OXFORDSHIRE COUNTY COUNCIL'S RESPONSE TO CONSULTATION ON THE FOLLOWING DEVELOPMENT PROPOSAL

Application no: 23/02399/REM

Proposal: Reserved Matters approval for 23/01080/OUT - Details of access, appearance, landscaping, layout and scale relating to the proposed development of Class E(g)(i) (formerly B1(a)) office/commercial building and Class E(g)(ii) (formerly B1(b)) Research and Development Units, plus associated car parking

Location: Land North Of Bicester Avenue Garden Centre, Oxford Road, Bicester

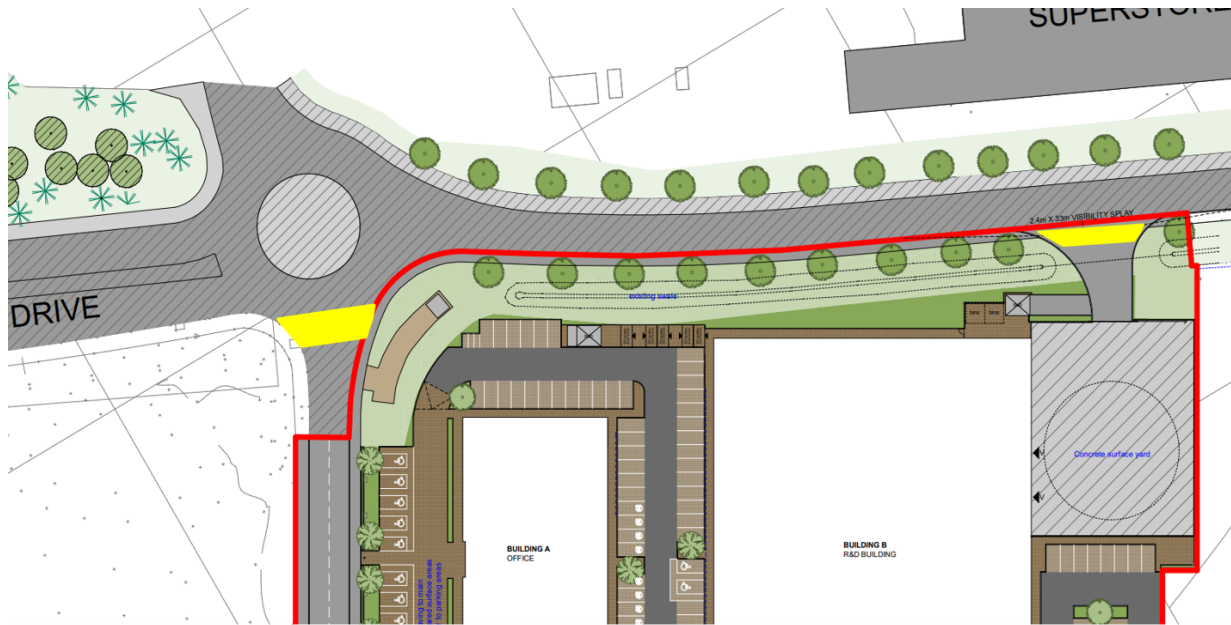
Cycle Parking - The level of provision for cycle parking spaces is noted to be immensely increased. However, I must add that the siting of the cycle parking facilities to the north of the building is not given due consideration. At present, users would need to access the cycle store by entering the shared entrance with the motor vehicles and then proceed all the way through the car park which is inconvenient and discouraging to the mode. I suggest that the parking facilities are relocated to areas close to the building entrances as I have illustrated in the snippet below (with yellow boxes).

In addition, all of the cycle parking is proposed to be double stacked which does not give regard to variations of cycle designs out there such as cargo bikes and electric bikes which are heavy and oversize for use on double stack designs. A proportion of these spaces must include sheffield stands to cater for these variations. Again, we shall require to see the design of the facilities prior to commencement of the development hereby proposed.

Cycle Parking Facilities

Prior to the commencement of the development hereby permitted, details of the covered cycle parking facilities shall be provided on the site in accordance with details which shall be firstly submitted to and approved in writing by the Local Planning Authority. Thereafter, the covered cycle parking facilities shall be permanently retained and maintained for the parking of cycles in connection with the development.

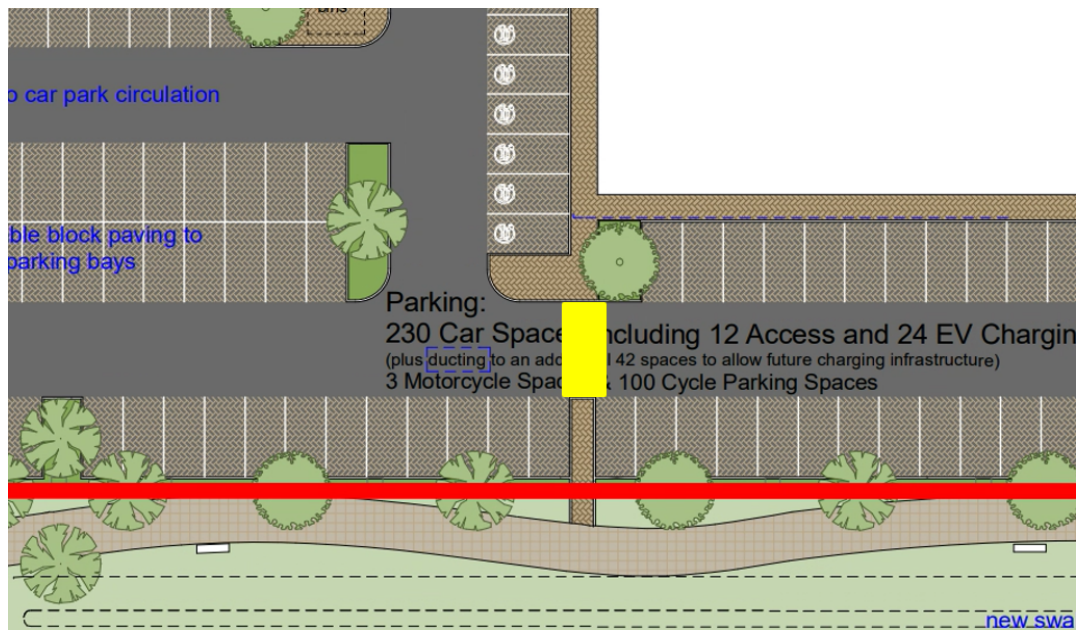
There is a 3m wide shared facility abutting Phase 2 parcel along Lakeview Drive which has not been appropriately connected to this development. A suitable crossing, preferably in the form of a side road entry treatment that gives priority use to active travellers is required. See snippet below.

The same issue is applicable across the service yard access further down along Lakeview Drive.

Pedestrian and Cyclist means of access

No development shall commence unless and until full details of the walking and cycling connections between the development and existing infrastructure including, crossings and their positions and layout have been submitted to and approved in writing by the Local Planning Authority. The means of access shall be constructed in accordance with the approved details and shall be retained and maintained as such thereafter.
